REVIEW OF SLOPE STABILITY ISSUES AT THE PROPOSED CARLOTA COPPER PROJECT, PINAL AND GILA COUNTIES, ARIZONA

OPEN-FILE REPORT 95-617

Prepared in cooperation with
the U.S. Department of Agriculture,
U.S. Forest Service

Figure 3. Map of the Eder slope and Powers Gulch area. Base from U.S. Geological Survey, 7-1/2-minute quadrangles: Inspiration (1945, photorevised 1982) Pinal Ranch (1948), Haunted Canyon (1949) and Superior (1948) photorevised 1981).

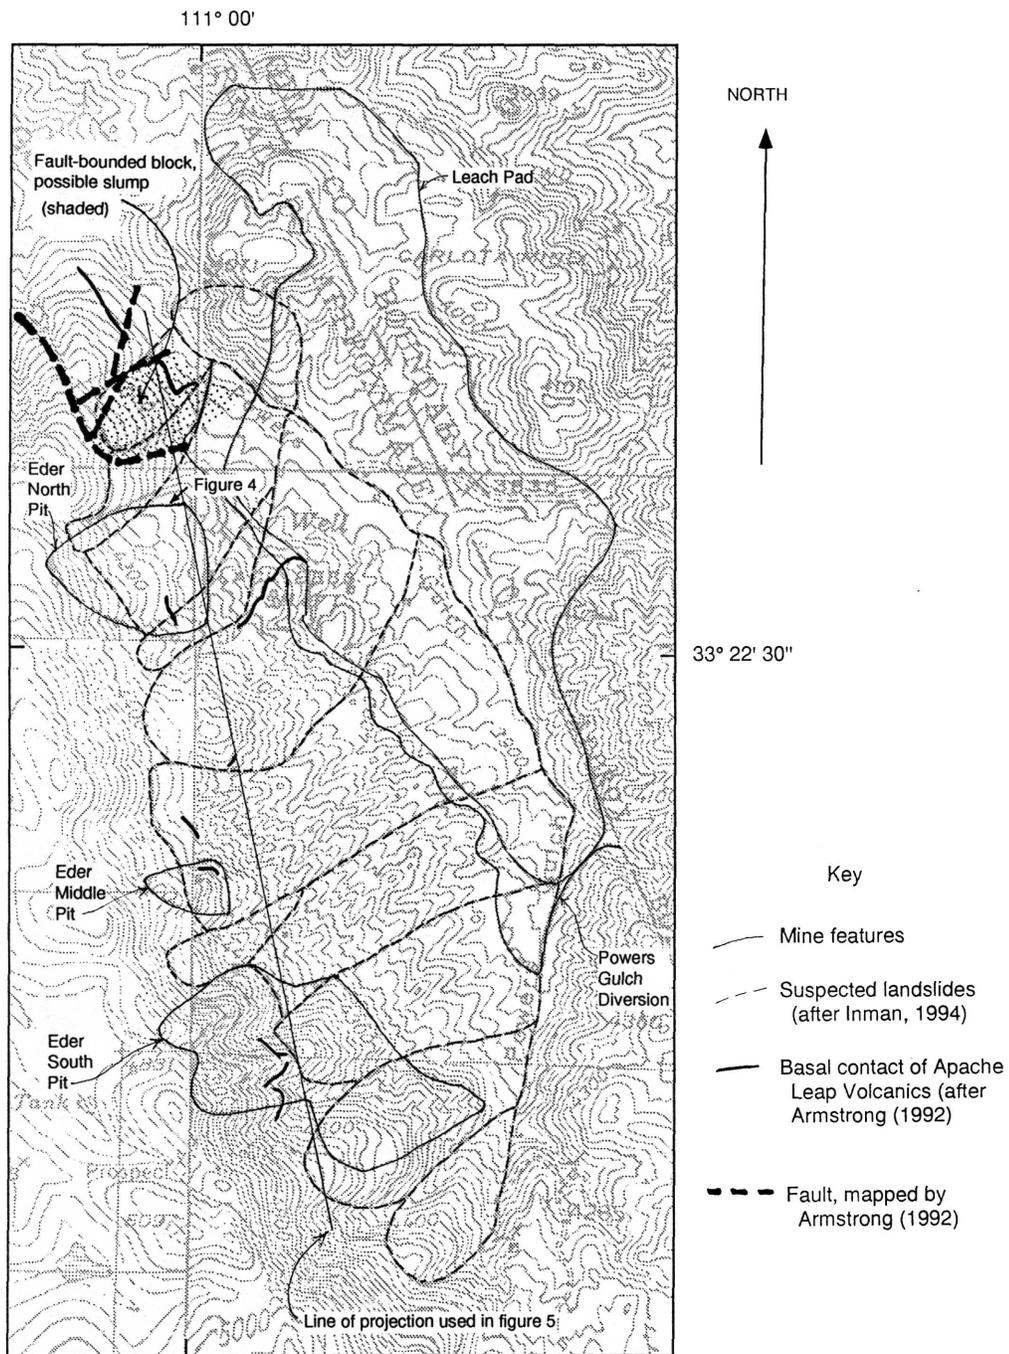
Much of the concern for stability of slopes near the Eder pits and the Powers Gulch diversion resulted from interpretation of aerial photographs (Inman, 1994). The slope where the Eder Pits are planned (fig. 3) was interpreted as a "nested landslide complex." In that area, the Apache Leap Volcanics support a rugged 500-ft-high cliff, and the Precambrian diabase and Pinal Schist support rolling, gently sloping topography. Five diamond drill holes sunk along the rim of the volcanics (400-1000 ft from the edge), in 1930 and 1931, passed through 500-1235 ft of dacite and tuff (Apache Leap Volcanics) and 70-410 ft of the underlying schist and granite (Peterson, 1962). Annotated aerial photographs, maps, and cross sections (Inman, 1994) interpret the dacite cliff as the adjoining scarps of the landslide complex and the flatter slopes below as the landslide deposits (fig. 3). Given this interpretation and the dacite's resistance to weathering and erosion, we expected to find huge blocks of dacite below the cliff and abrupt offsets in the basal contact of the Apache Leap Volcanics at the edges of such blocks. We also expected Pinal Schist and diabase to be obscured by the dacite blocks within about 1000 ft of the base of the cliff.

We observed little evidence of large-scale landslide deposits, rather we found small debris-flow or debris-avalanche deposits. The Pinal Schist, although badly weathered, showed little evidence of shearing or of compression parallel to the slope. Outcroppings of Pinal schist were present at the base of the cliff and at many locations between there and Powers Gulch. No huge blocks of dacite exist below the cliff; we observed dacite only in blocks as large as 10 ft. The angular, randomly oriented, dacite blocks occur in heterogeneous, matrix-supported deposits (fig. 4). Surficial deposits including dacite are less than 30 ft thick and are locally absent; thus the total volume of displaced dacite is much smaller than would be expected if large-scale failures had occurred.

Several observations indicate potential rock-fall and debris-flow hazards to the mining operation and the Powers Gulch Diversion and potential slippage of the Eder Rock dump. Adequate investigation and design precautions should prevent these potential hazards from developing into serious problems. Recent rock-fall deposits partially block some of the road ways, and steep eastward-dipping joints in the dacite may facilitate local rock fall in the open pit areas of the Eder slope. Thin (<30 ft) debris-flow deposits and alluvium lie on the Pinal Schist in the area between the cliff and Powers Gulch. Desiccation cracks in the surface of these deposits indicate that they may contain expansive clays. Study of the distribution and age of debris-flow deposits in the alignment of the Powers Gulch diversion may indicate the likelihood that future debris flows could block the diversion and whether a need exists for measures to protect Powers Gulch diversion from blockage. The surficial deposits may form an unstable foundation for the Eder Rock Dump area if the deposits have a high clay content and additional water enters the deposits through the dump and softens the clays. The possibility of differential settlement of the leach pad liner as suggested by Inman (1994) may also exist if these deposits are highly clayey and of significant thickness under the leach pad.

Figure 5. Outcrop elevation of the basal contact of Apache Leap volcanics on the Eder slope. Projected to line shown on figure 3.

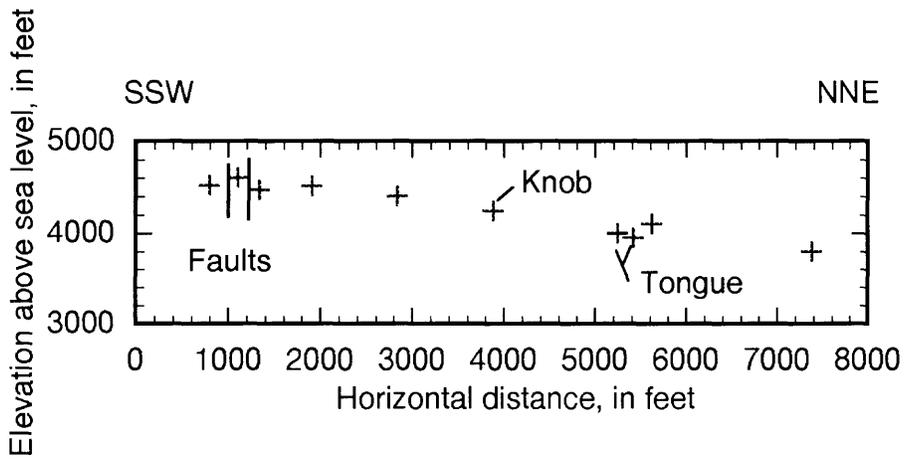
The contact between the basal tuff and vitrophyre unit of the Apache Leap Volcanics and the underlying schist or diabase dipped fairly uniformly toward the north (fig. 5). Slight variations occur near small faults in the Eder South Pit area and near the Eder North Pit. The faults near the Eder South Pit strike east or northeast, are roughly perpendicular to the contours, and are evidently discontinuous (Armstrong, 1992); their pattern does not seem consistent with slumping because they do not define discrete blocks that are down relative to the surrounding bedrock. A prominent knob near the Eder North Pit is the only area that topographically resembles a slide block; however, the contact elevation is on a consistent trend with points to the south (fig. 5). The basal contact dives abruptly in the Eder North Pit area where a narrow finger of tuff and vitrophyre blankets the Pinal Schist. This narrow finger is consistent with known relief on the basal contact of the Apache Leap Volcanics (Peterson, 1962) and appears to be in normal contact with the underlying schist. A fault-bounded block north of the North Eder Pit may be a slump block. The block lacks topographic features of a slide block, but the fault pattern mapped by Armstrong (1992) is consistent with movement as a slide. Regardless of the block's origin, excavation at its toe during construction of the Powers Gulch Diversion may destabilize the block and allow it to move on the faults. Stability of the block should be thoroughly studied during the planned geotechnical investigation for the Powers Gulch Diversion.

Figure 6. View looking northward of the planned ravine site of the Cactus Southwest Rock Dump. Carlota/Cactus pit will be located to right, behind ridge line. Section A'-A is shown in figure 8.

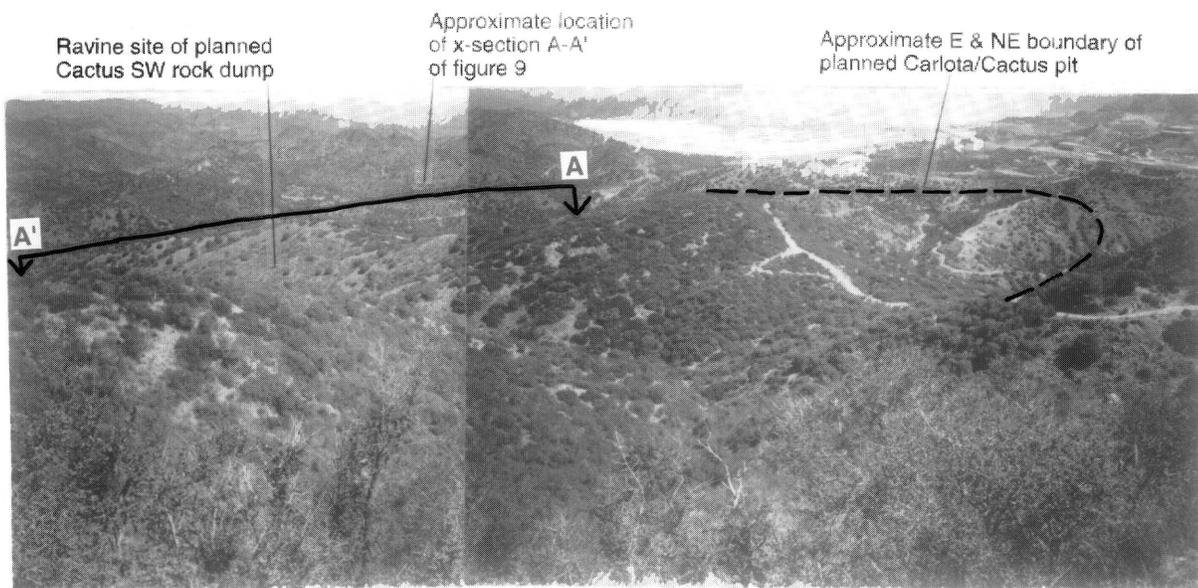
The planned location for the Cactus SW rock dump is a ravine approximately 2800 ft south-southwest of the center of the Carlota/Cactus pit (figures 2 & 6). The ravine is at a mean elevation of approximately 4125 ft, and the top of the dump will ultimately reach an elevation of 4360 ft. The proximity of the dump to the southern boundary of the Carlota/Cactus pit, and its ultimate surface elevation 1400 ft above the bottom of the Cactus pit, has focused some concern on the issue of stability of the southern pit wall.

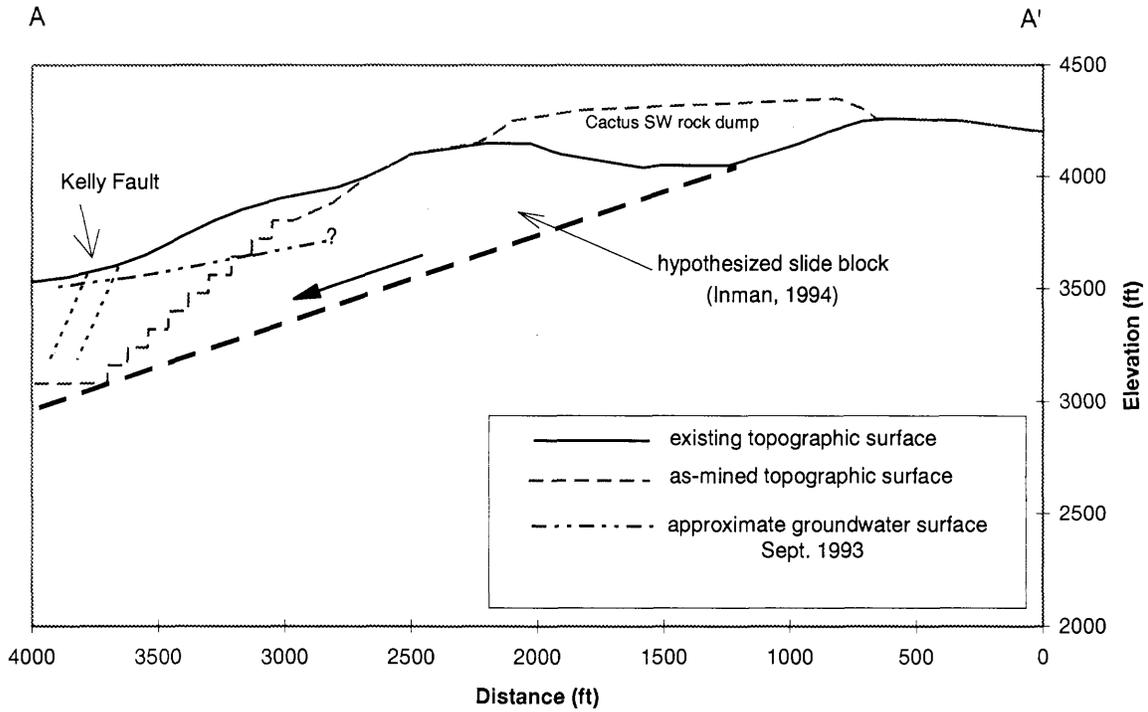
A major question regarding the southern pit wall stability was raised by Inman (1994). Based on aerial-photo analysis, he concluded that the ridge between the pit and the Cactus dump ravine is a large block slide (figure 7). In this interpretation, the southern slope of the ravine represents a remnant slide surface dipping approximately 20° toward the pit, with about 1700 ft of down-dip displacement (1500 ft of lateral displacement) of the hypothesized slide block (figure 8). Mining of the Cactus pit would expose the slide surface in the pit wall or near the bottom of the pit, effectively removing any lateral restraint from the base of the hypothesized slide block. This removal of lateral restraint, coupled with increased vertical loading of the slide block from the Cactus SW dump, was interpreted to pose potentially serious concerns for the pit-wall stability Inman (1994).

The field reconnaissance focused along the top and sides of the ridge where the hypothesized shear surface would intersect the ridge (figure 7), and also along the north side and bottom of the ravine, where we looked for evidence of shear deformation in the exposed schist and granite. No evidence of offset or shear failure was found in the rocks along the eastern side of the ridge (traverses 1,2,&3, figure 9) where the slide surface was projected to extend. Here, the predominantly granite rocks were observed to be unaltered and relatively unfractured. Some minor slickensides were found on a few small pieces of granite (<1 ft³) near the ridge top (S in figure 9), but no evidence of large scale shearing was apparent.

In his air-photo analysis, Inman (1994) shows the northwest side of the suspected block slide (fig. 7) terminating on the Bundy fault, where schist on the southeast is in contact with diabase on the northwest side of the fault. If the ridge to the southeast of the Bundy fault were emplaced as a result of displacement on a low-angle shear surface, then some offset in the ridge line and drainage at the Bundy fault would be expected. The ridge line and drainage, however, continue northwestward across the Bundy fault without any significant offset in alignment.

The field reconnaissance and review of geologic and topographic maps has produced no evidence that the ridge between the Carlota/Cactus pit and the planned location of the Cactus SW rock dump is a large block slide. It is understandable how such an interpretation, based solely on air-photo examination, might have been made. This interpretation, however, apparently relies entirely on speculation about the origin of certain topographic features, which, without other supporting evidence, is unwarranted. The 1700 ft of hypothesized displacement along the slip plane also appears to be based only on alignment of topographic surfaces in cross-section, which by itself does not justify such a hypothesis. The absence of significant alteration or fracturing in the vicinity of the hypothesized slip plane, and the lack of notable offsets in geologic and topographic features, argue against the existence of a shear zone and the interpretation that the ridge is a large slide block.

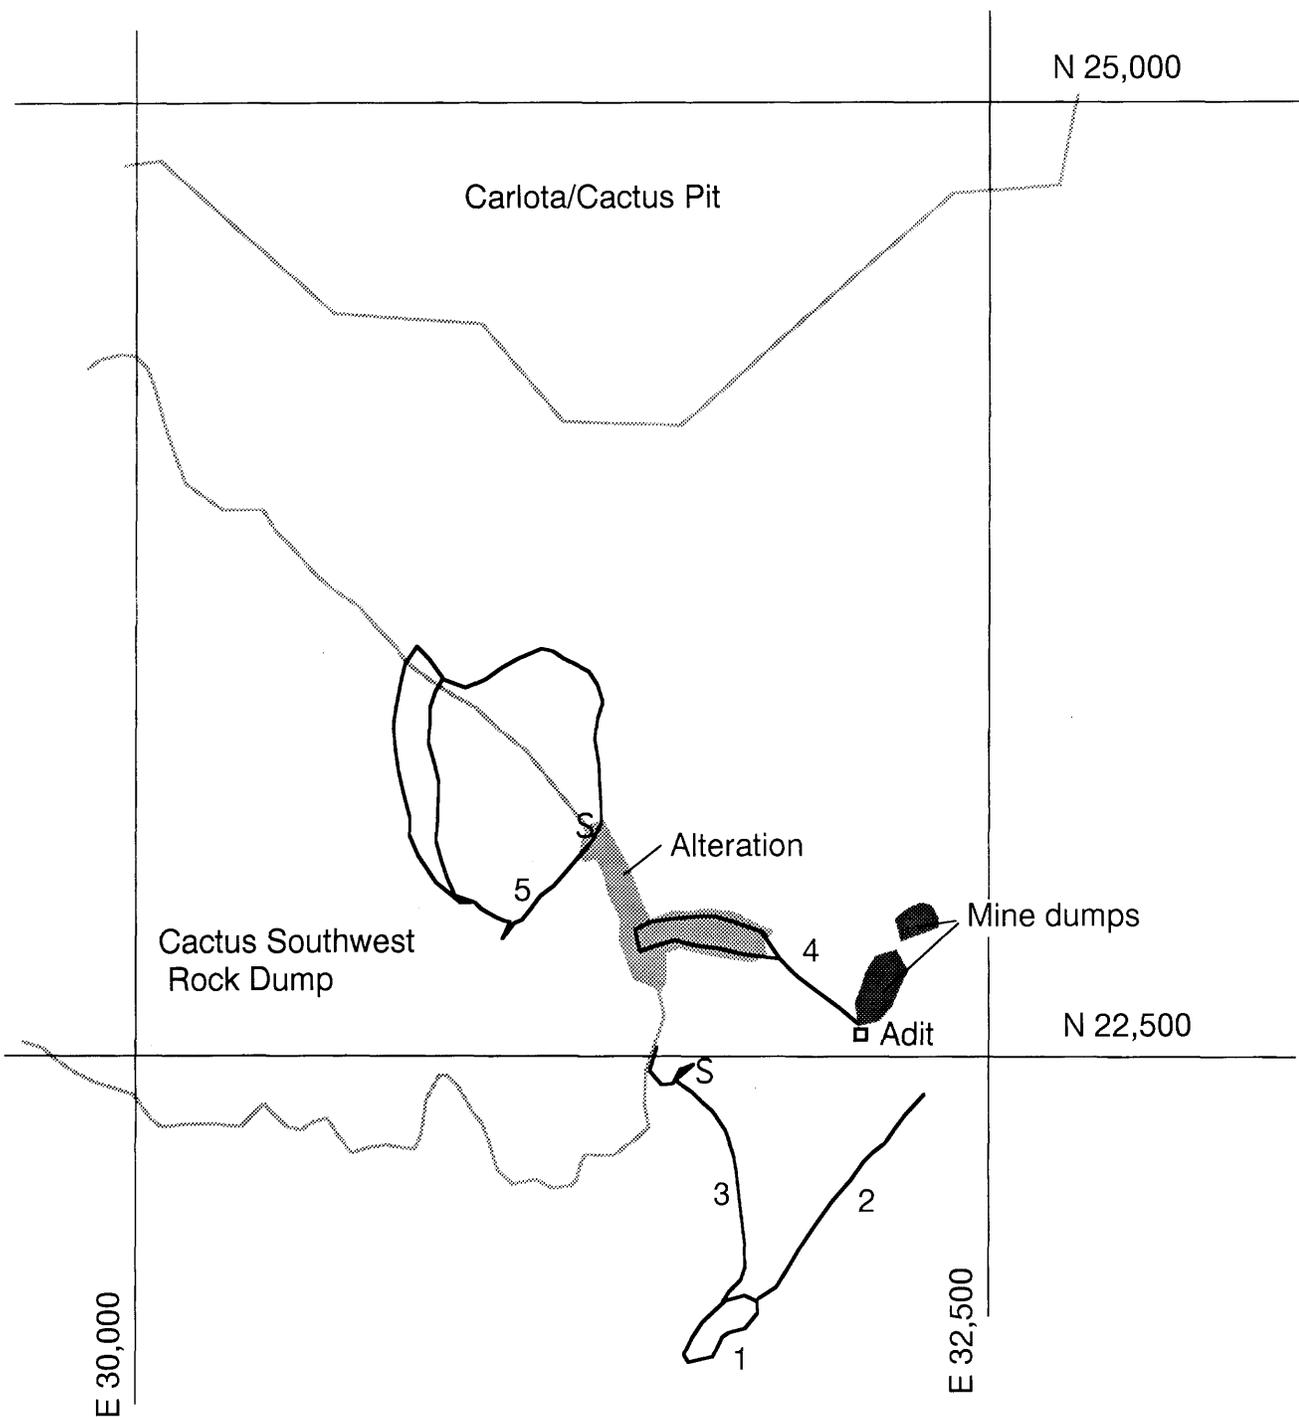
Slightly altered granite was present at a lower elevation in a saddle along the ridge top (traverse 4, figure 9), but the alteration appeared to be localized to the saddle area. An old mine adit and rock dump near the saddle and zone of alteration indicate the presence of mineralization. The old mine workings are located on a contact between the Pinal schist and the intrusive "Granite on Manitou Hill", and no faulting was mapped in the area (Armstrong, 1992).

Traverse 5 (figure 9) into the ravine west of the saddle did not reveal any evidence of alteration or shearing. The granite in the flank and bottom of the ravine was weakly foliated and jointed, and locally covered by a thin residuum. The contact between the granite and schist is transitional. The schist, locally covered by a thin residuum, is jointed but appears relatively competent.

If the ravine where the Cactus SW rock dump is planned to be located had been formed by a large slide block with at least 1700 ft of displacement, then there should be obvious indications of alteration and fracturing both in the flanks and bottom of the ravine, and along the eastern flank of the ridge where the slide surface would project through. No evidence was found to indicate that large-scale shearing and deformation has taken place at these locations.
